## STAR ONLINE PUBLICATION

**Case Number:** S2123000022

### Symptom/Vehicle Issue: Steering Damper Mounting Information

Fig 3 orientation of the intake bulge (down)

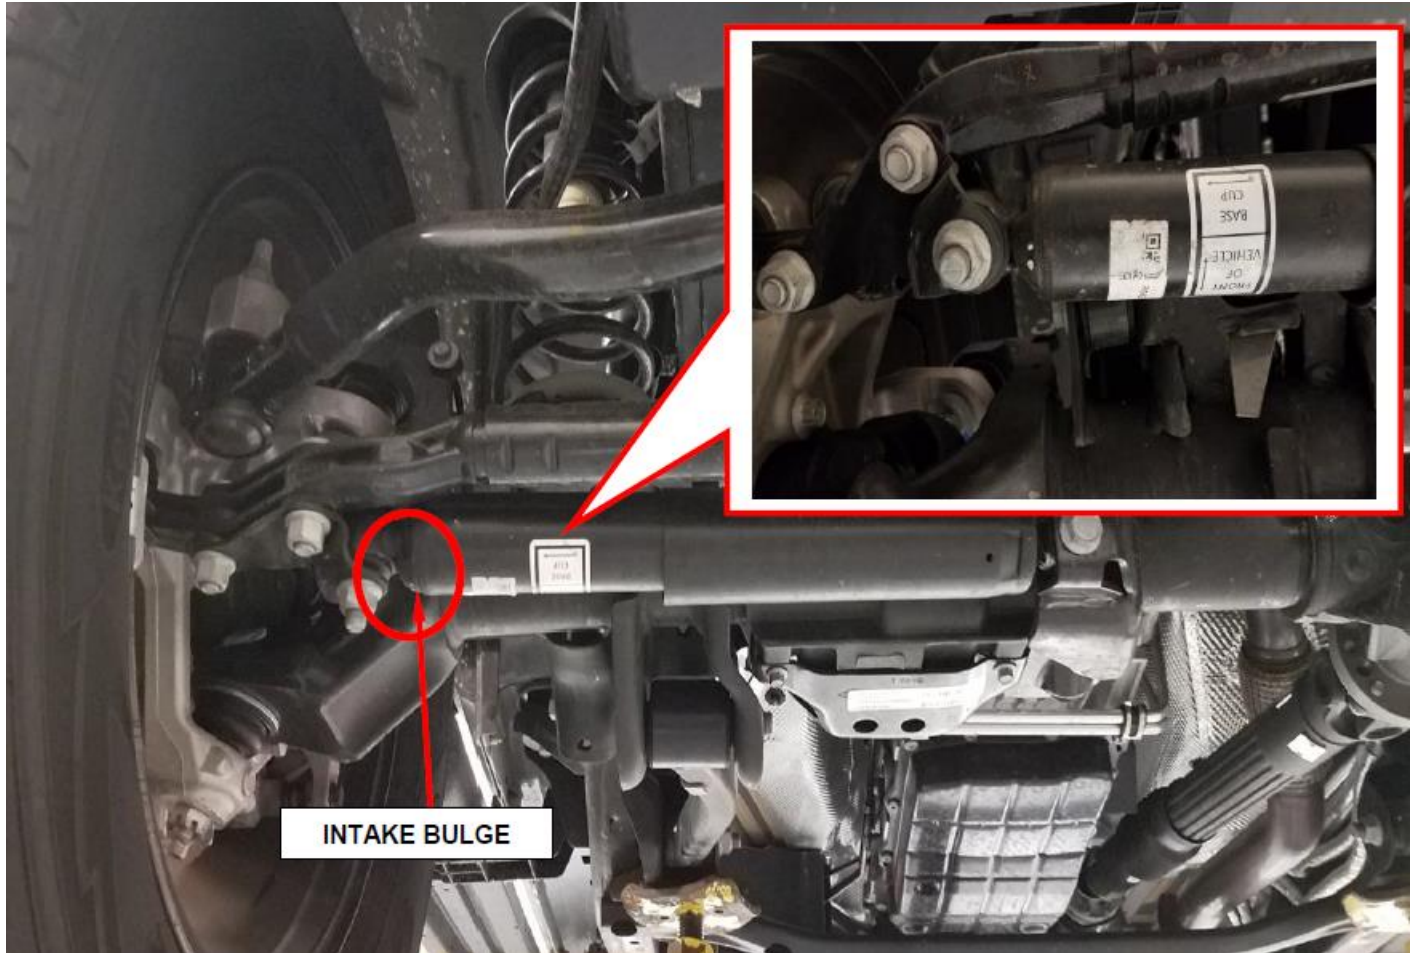
Proper installation has the intake bulge position down indicated in fig 3. NOTE>>> this is critical for proper damper operation.
